Product Change Notification / KSRA-16XDWZ131

CCB 4198.002 Final Notice: Qualification of ASSH as a new assembly site for selected 25AA640xx and 25LC640xx device families of 36K wafer technology available in 8L TSSOP package.

CCB 4198.002
Pre and Post Change Summary
PCN #: KSRA-16XDWZ131

Lead frame comparison

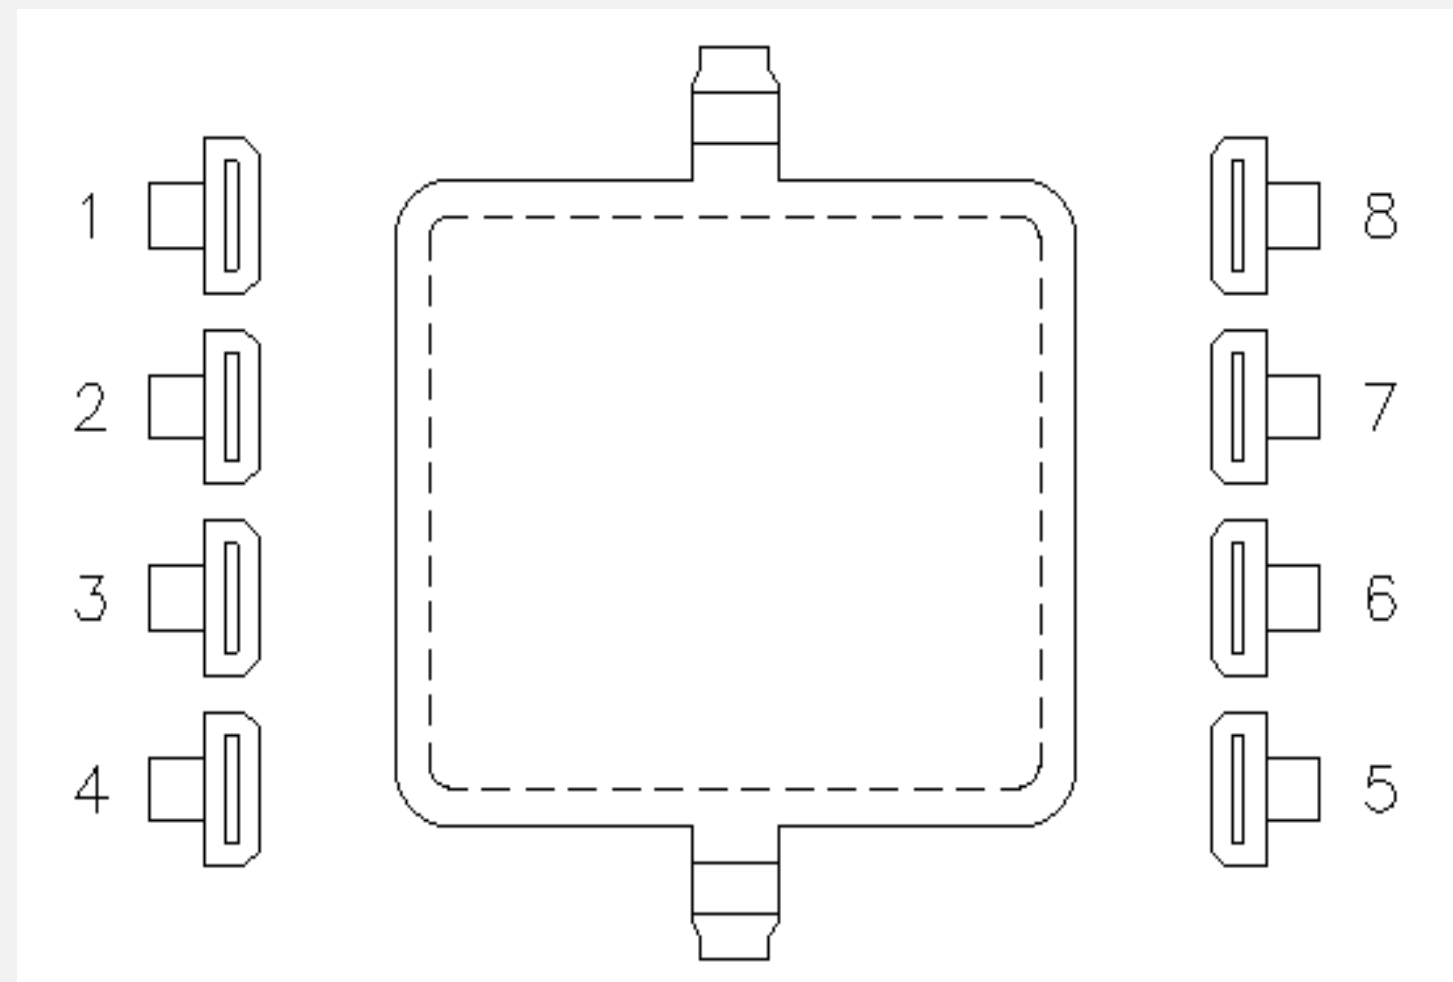
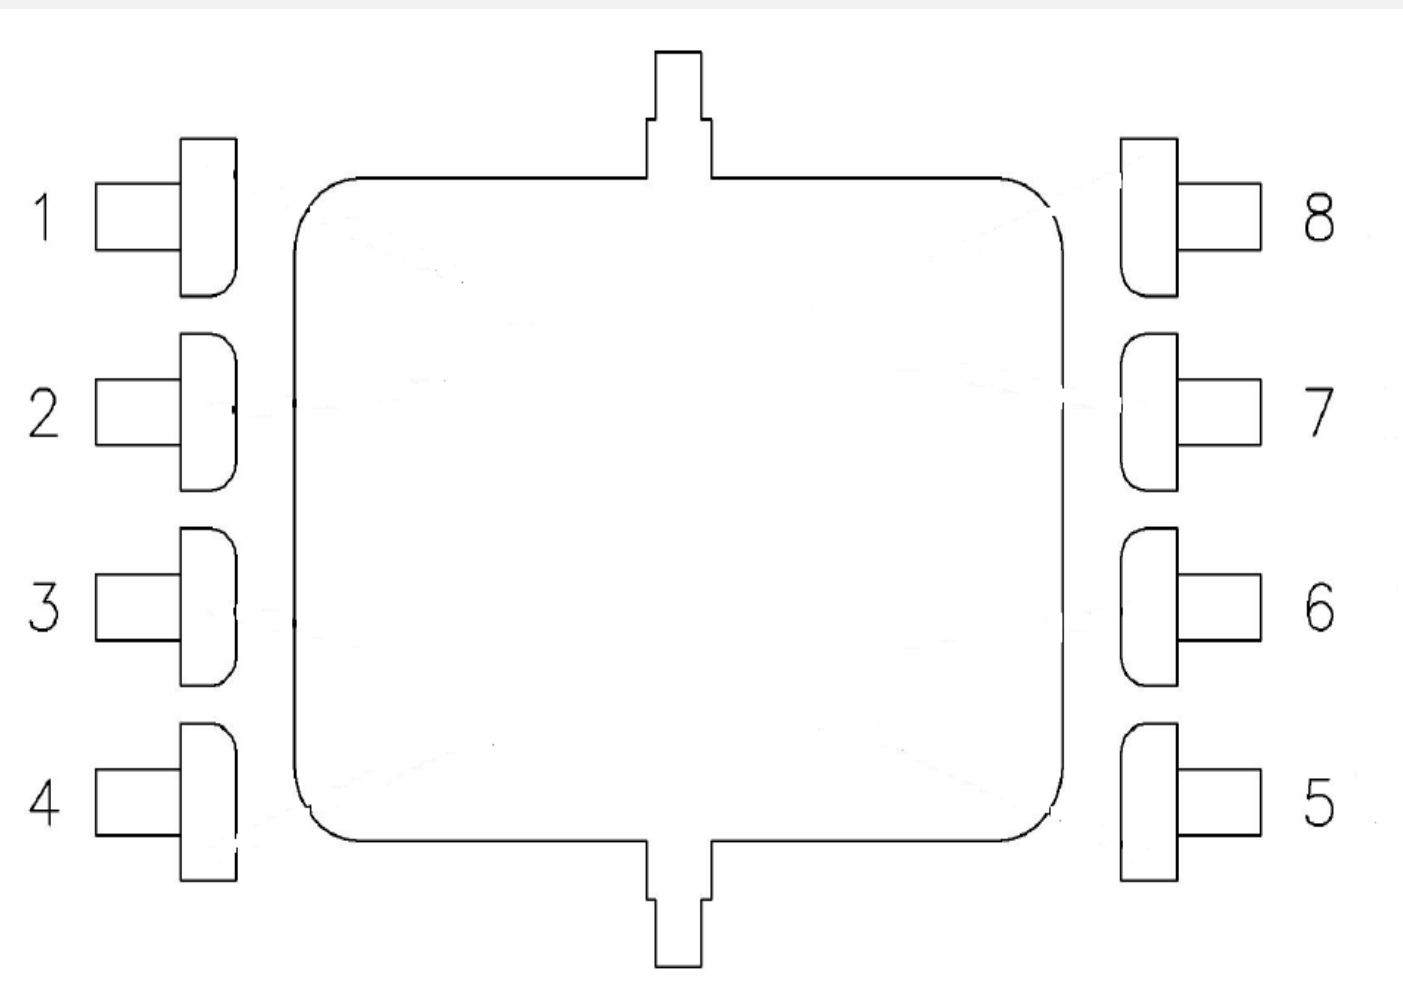
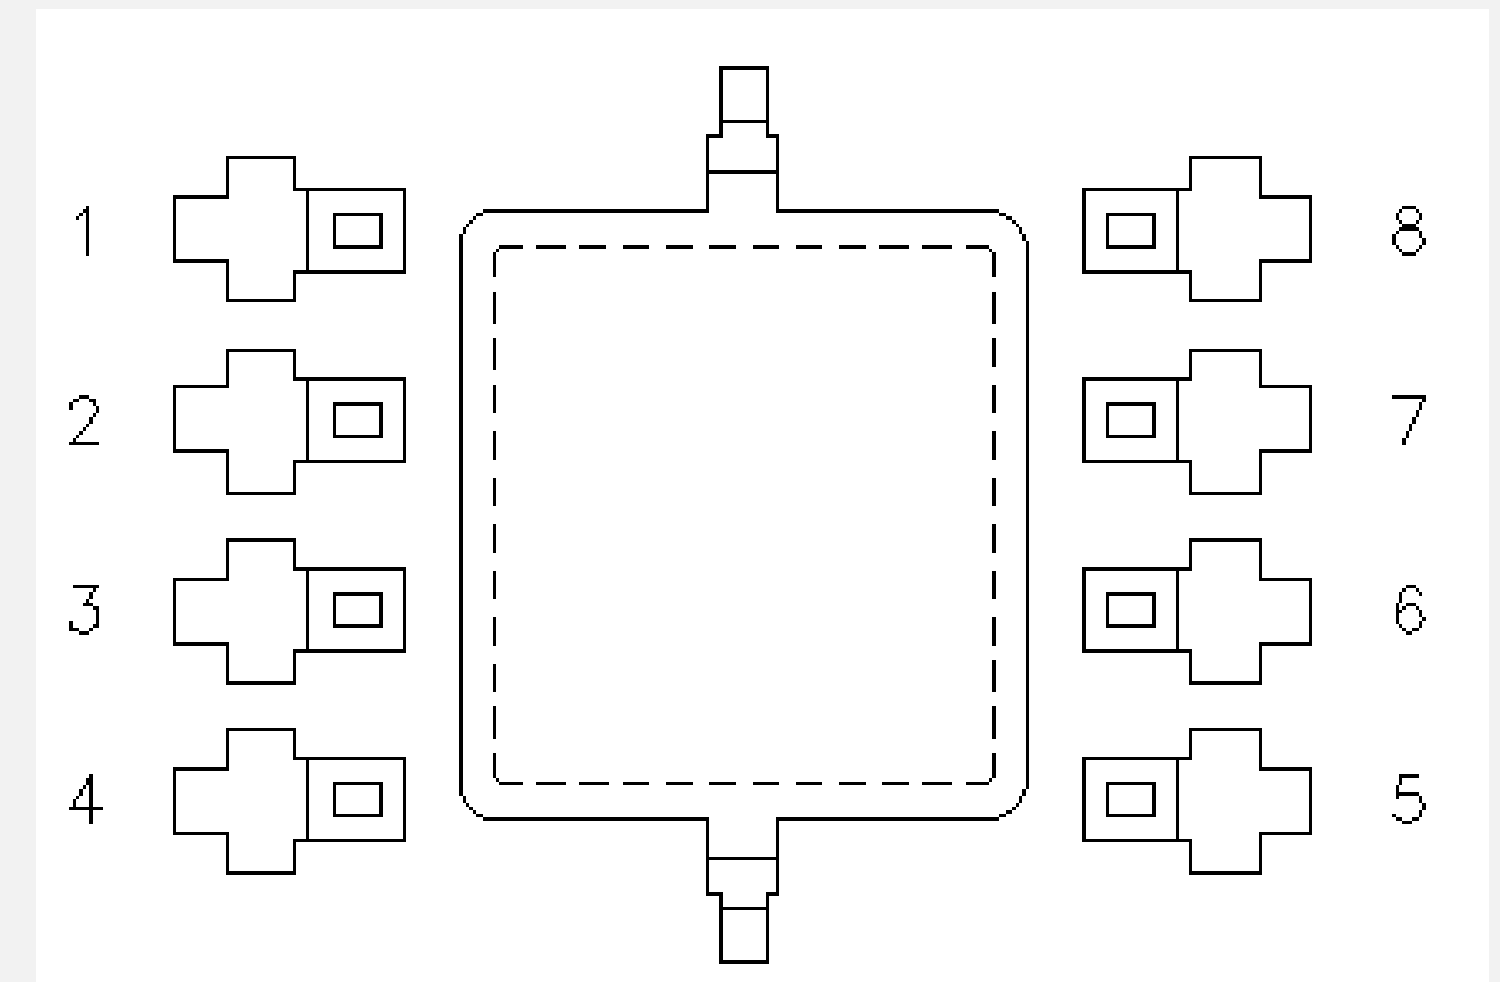
Lead frame lead-lock No	**Lead frame lead-lock** No	**Lead frame lead-lock** Yes

Lead frame comparison

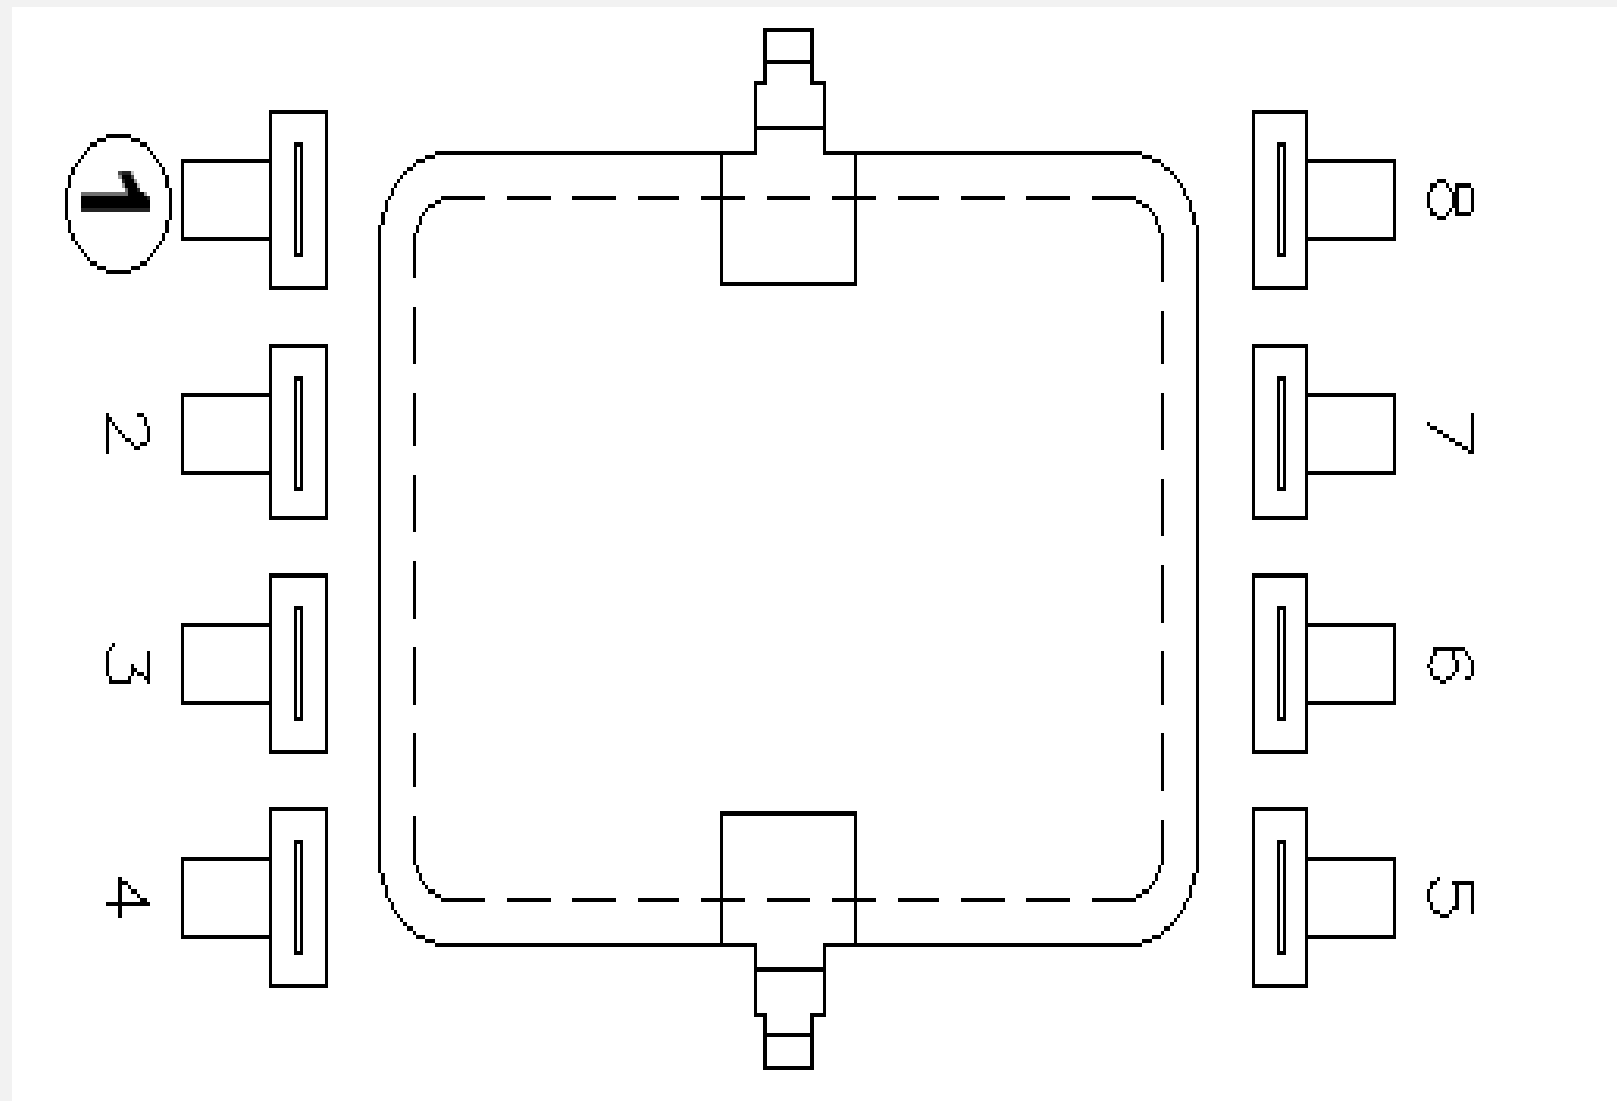
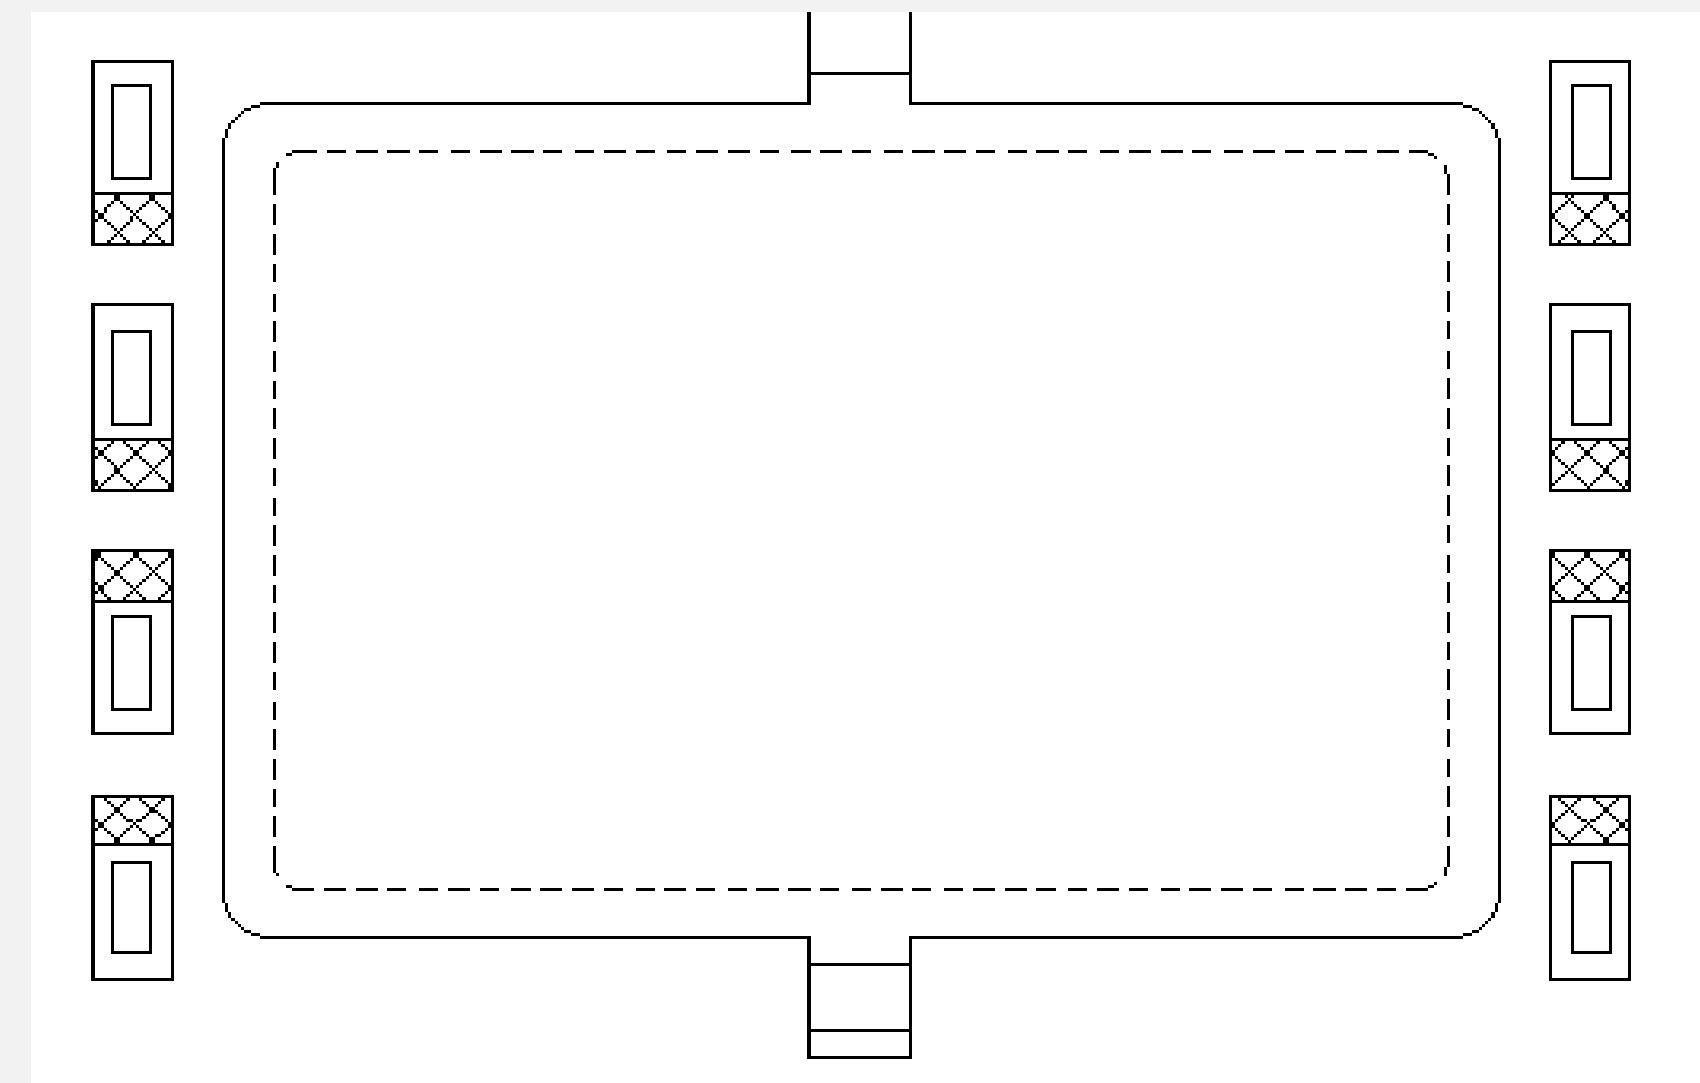
Lead frame lead-lock	No

Lead frame lead-lock	Yes
